**Re: Fields Brook Action Group Comments on Proposed ESD
for Detrex Corporation Source Area (OU5) – Fields Brook
Superfund Site, Ashtabula, Ohio**

THE FIELDS BROOK ACTION GROUP COMMENTS ON PROPOSED ESD FOR DETREX CORPORATION SOURCE AREA (OU5) FIELDS BROOK SUPERFUND SITE, ASHTABULA, OHIO

Figure 1
DNAPL Thicknesses Observed in Detrex Source Control Monitoring Wells
Detrex Facility, Fields Brook Superfund Site, Ashtabula, OH

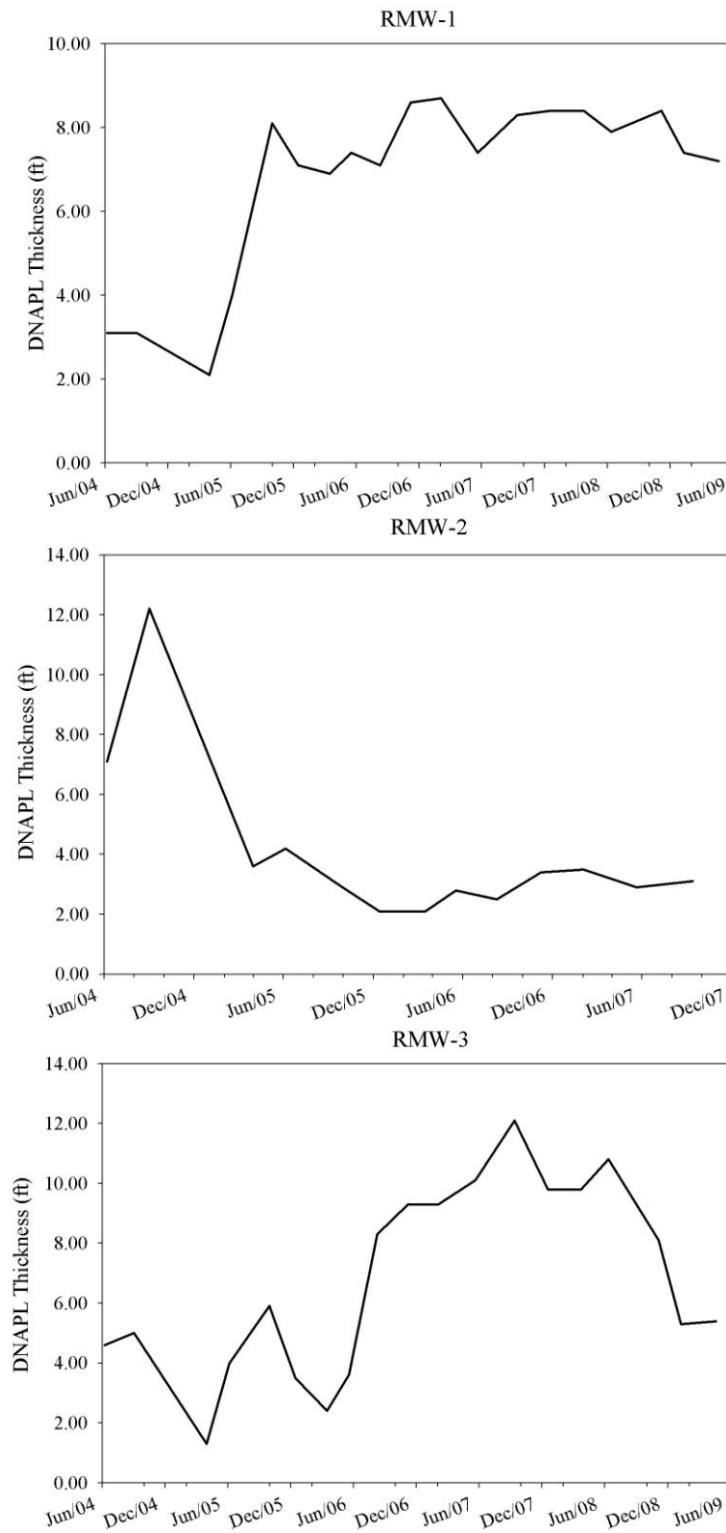
To date, Detrex has installed 14 of the 40 DNAPL extraction wells contemplated in the SCOU ROD (USEPA, 1997a). These extraction wells are oriented in a V-shaped pattern in the northern portion of the Facility along the periphery of the former impoundment area. The placement of the wells along the edges of the primary source area is sub-optimal because DNAPL has to flow from the former impoundment area to the wells (by gravity) before it can be captured. This placement of wells is serving to expand the DNAPL plume by pulling it towards the edges, rather than shrinking the plume (the typical objective for remediation). Despite the poor well locations (i.e., approximately 100 feet away from the center of the former impoundment area), several feet of DNAPL (up to 8 feet) continues to accumulate in the current recovery system's monitoring wells (Figure 1), a clear indication of the volume of recoverable DNAPL present at the former impoundment area.

Detrex should install active DNAPL extraction wells in the heart of the DNAPL plume (i.e., within the former impoundment area) where the greatest thickness of DNAPL is expected to be present and has been observed in monitoring wells. Placement of extraction wells within rather than around the impoundment area is consistent with the well layout recommended in the ROD (Figure 2). By starting at the source, the extraction wells will draw DNAPL inward towards the center of the plume, instead of the current (and proposed) wells that are on the periphery of the plume and will spread the plume. We recommend starting with a small number of extraction wells (e.g., 4 to 6 wells) in the center of the DNAPL source area and collecting detailed observations of system performance so that the well configuration can be optimized and then expanded to a full scale system. In summary, placement of

FIGURE
3

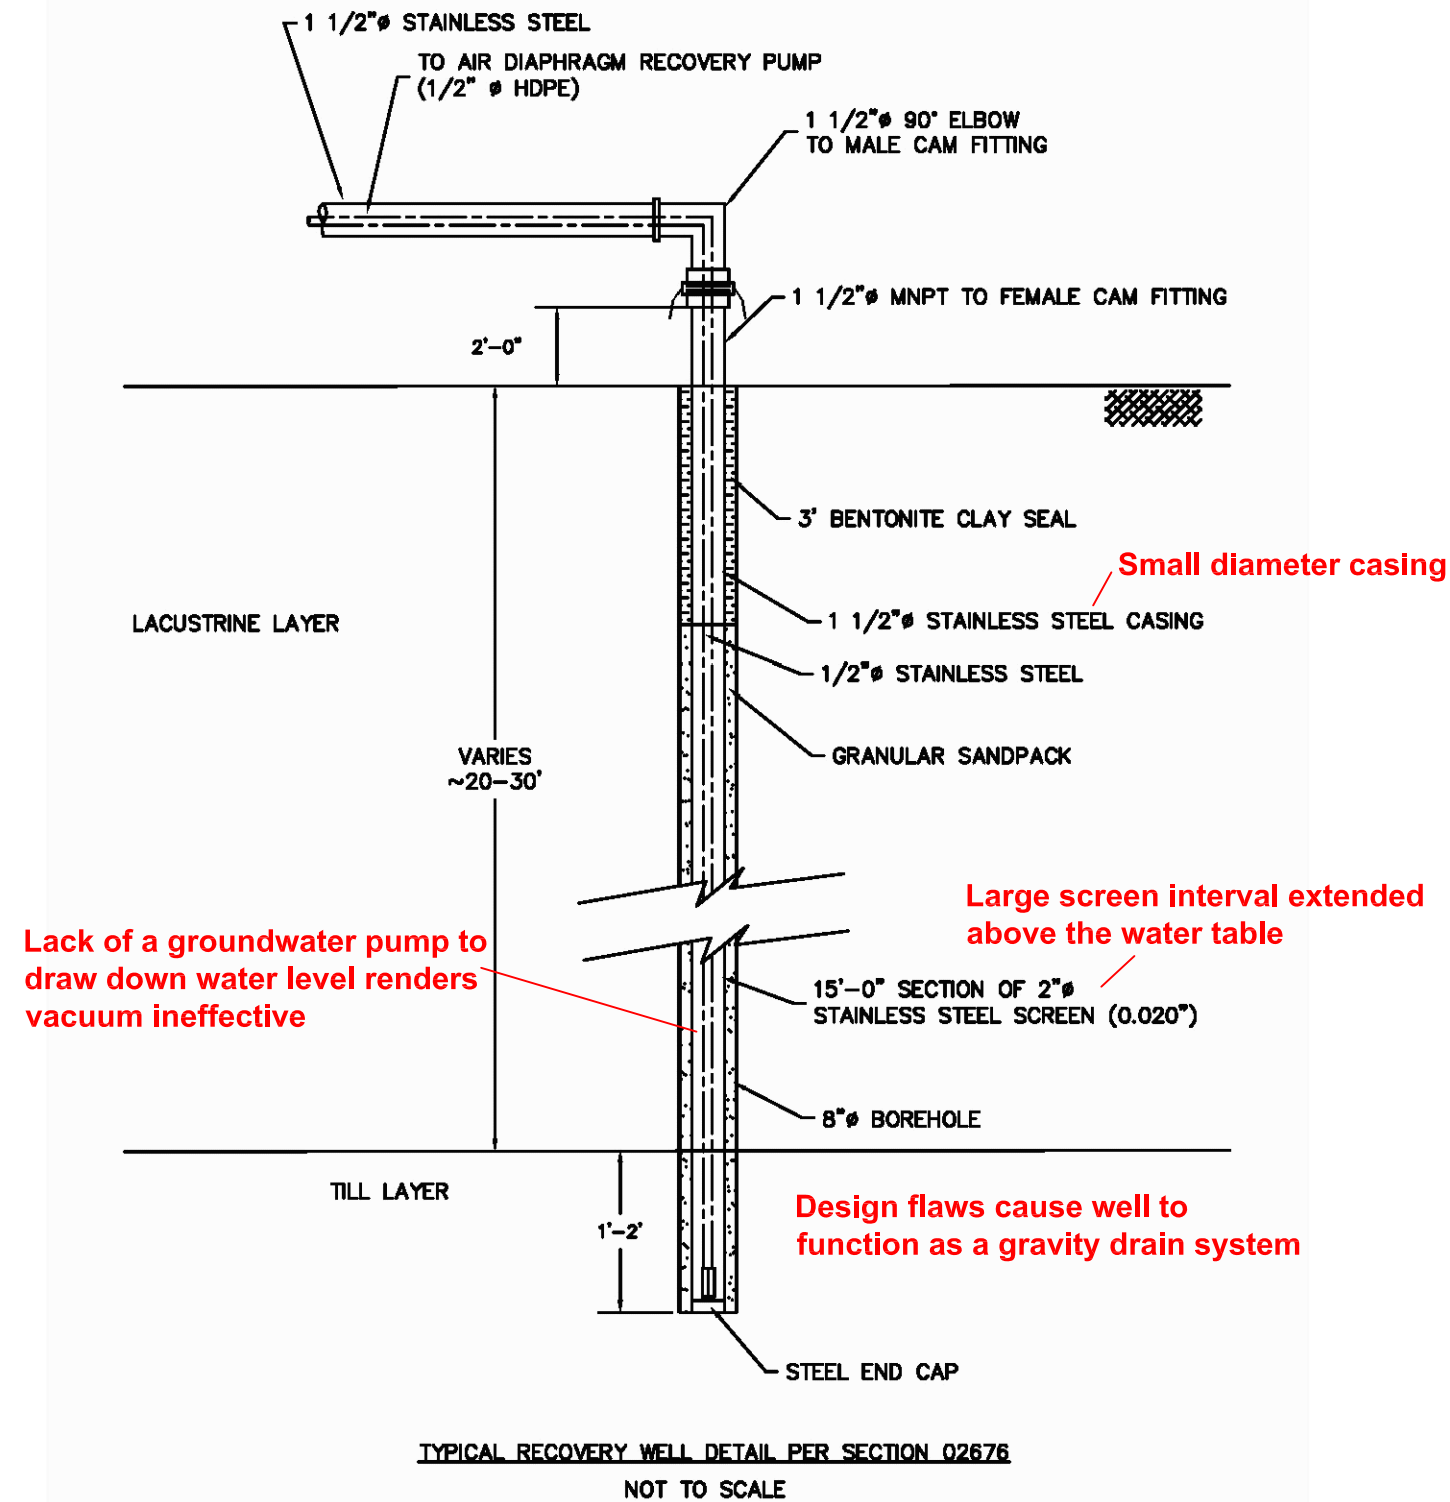
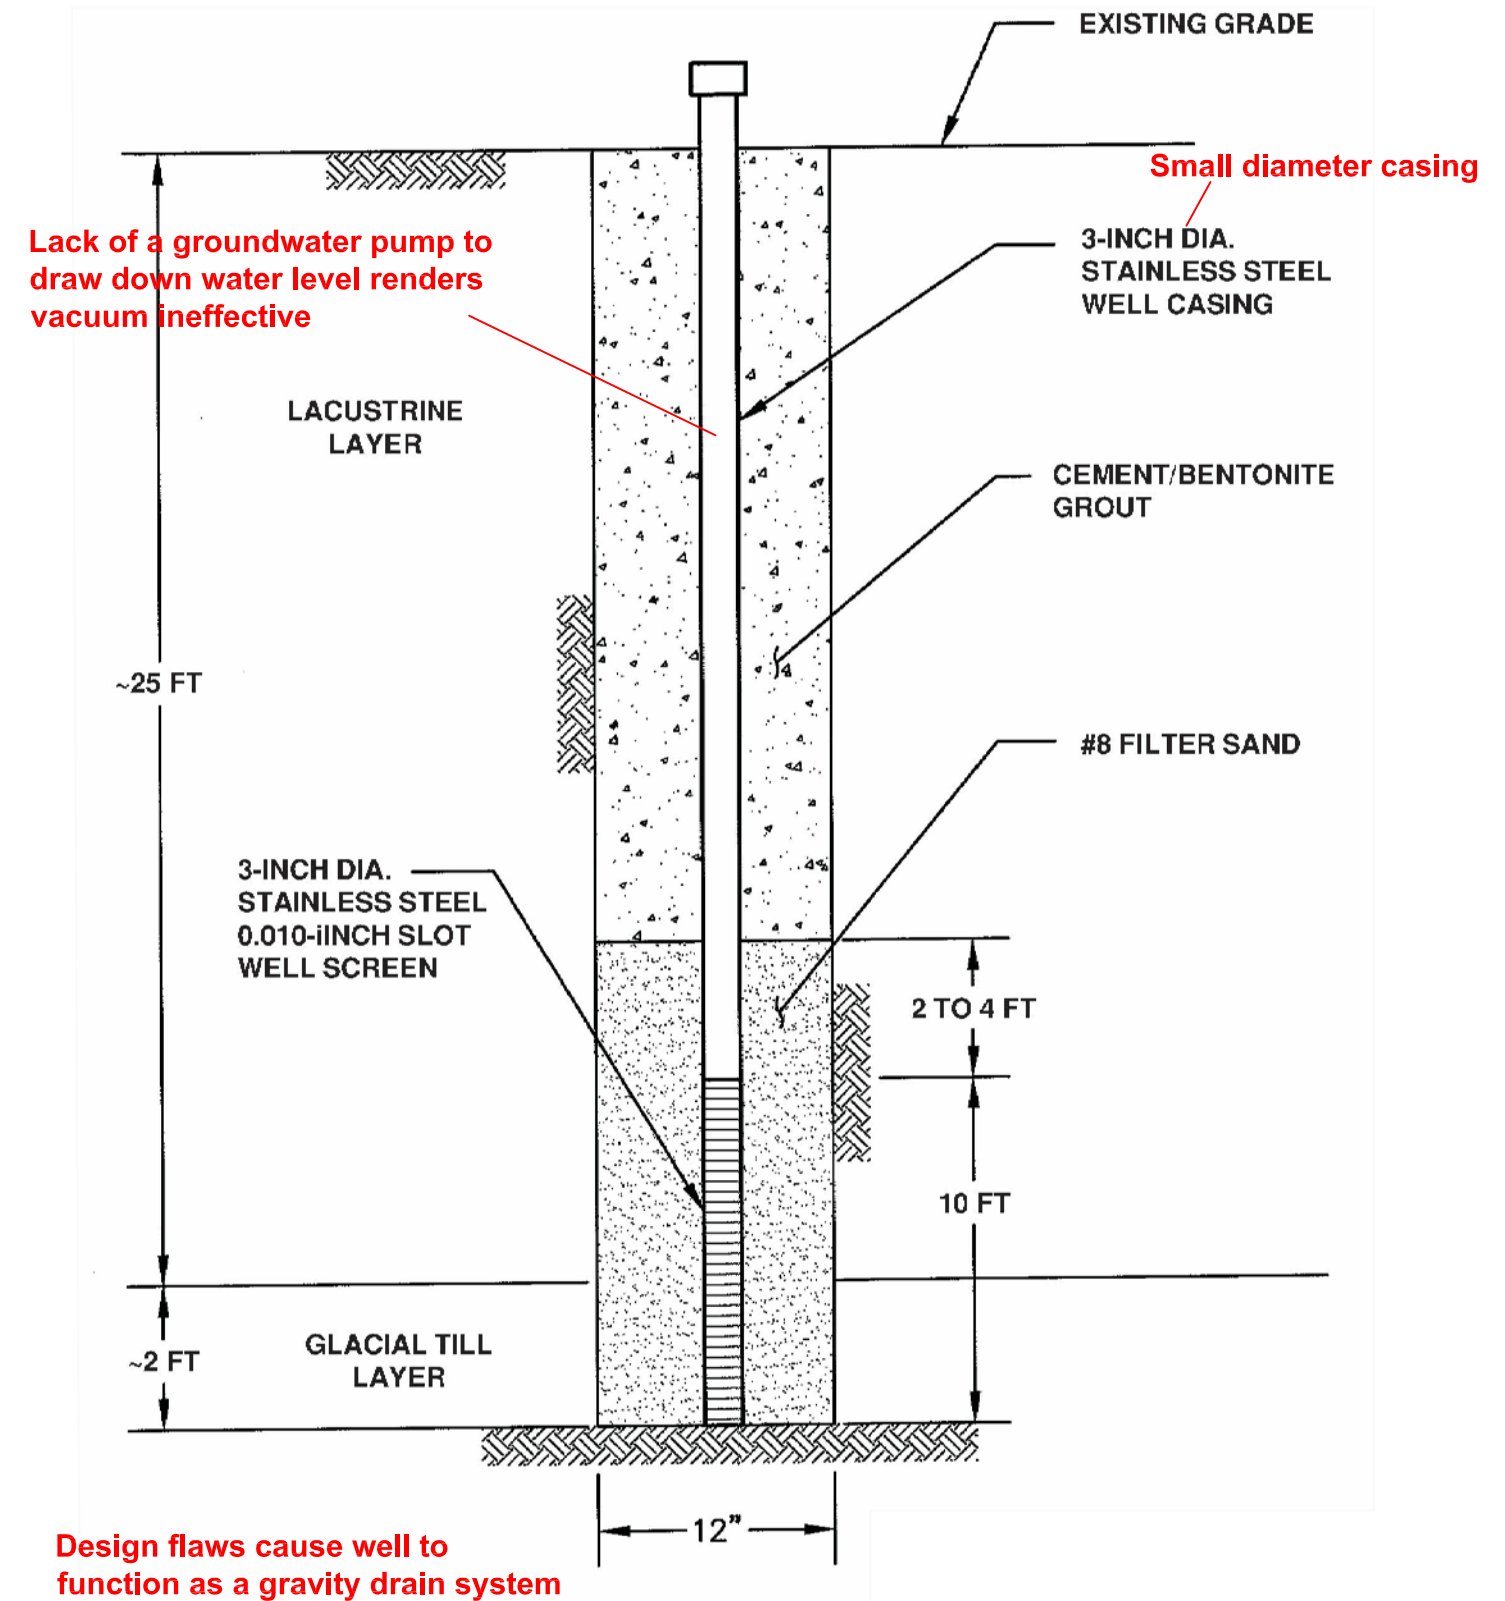
The current Detrex DNAPL recovery system utilizes equipment that is not appropriate for site conditions (e.g. improper well design, wrong type of vacuum pump) and therefore reduces DNAPL removal efficiency. The recovery wells are small in diameter (originally only 2-inch diameter) and are not designed or operated in a manner that can effectively apply vacuum to recover DNAPL present in the subsurface. The current Detrex design creates a minimal amount of suction on the DNAPL layer, using a small positive displacement pump and suction manifold connecting this single pump to multiple wells, making the design little more than a passive remedy. In order for the applied vacuum to mobilize DNAPL into the recovery well and remove accumulated free product, the water level in the well must be simultaneously drawn down³. The combined action of applying vacuum and drawing down the water level in the well will maximize the well's potential to draw DNAPL into it. Since Detrex does not simultaneously apply vacuum and extract groundwater from its recovery wells, the applied vacuum, does not allow for effective DNAPL recovery.

Furthermore, the vacuum pump that Detrex has utilized is a low-vacuum (vacuum of about 5 inches of mercury) high-flow pump that is not suitable for vacuum-enhanced DNAPL recovery. Given the low vacuum being applied, even if the recovery wells were properly designed and operated, the vacuum would not be sufficient to significantly induce DNAPL from the formation to flow towards the well. Thus, the system has always operated and would continue to operate as a gravity drainage system—an ineffective method for DNAPL extraction. Schematic drawings of the passive recovery wells currently in operation at the Detrex facility and/or proposed by Detrex (URS, 2011) are shown in Figure 3. The figure has been annotated to point out some of the design flaws in the proposal.

Detrex should redesign its system so that it can function as an active and effective DNAPL extraction remedy. Extraction wells should be larger in diameter so that they can accommodate the equipment needed for monitoring and extraction of groundwater and DNAPL. The screened interval of the wells should be narrowly constrained to the DNAPL bearing zone, so that only groundwater and DNAPL (i.e., minimal vapor stream) are produced from the well. DNAPL should be extracted *via* a dedicated submersible positive displacement pump installed in an unscreened sump at the bottom of the well that extends into the glacial till. An interface probe should be utilized to ensure that DNAPL is not

For applying vacuum, Detrex should utilize a high-vacuum (*i.e.*, a vacuum of 25 inches of mercury or greater), low-flow pump, consistent with industry best practices for DNAPL extraction in similar low permeability settings. The extraction wells should also have a groundwater extraction pump (above the top of the DNAPL layer but below the minimum desired groundwater level in the well) so that the well's water level could be drawn down simultaneously as vacuum is being applied. A level control should be used in conjunction with the groundwater pump to ensure that the water table stays sufficiently above the DNAPL layer to prevent mixing of the two fluids. Drawing down the well's water level while simultaneously applying vacuum to the well's headspace will maximize the induced DNAPL gradient toward the well, and will considerably increase DNAPL recovery rates. In addition, continuous pumping of DNAPL will minimize the emulsion and crystallization formation problems reportedly observed at the current system.
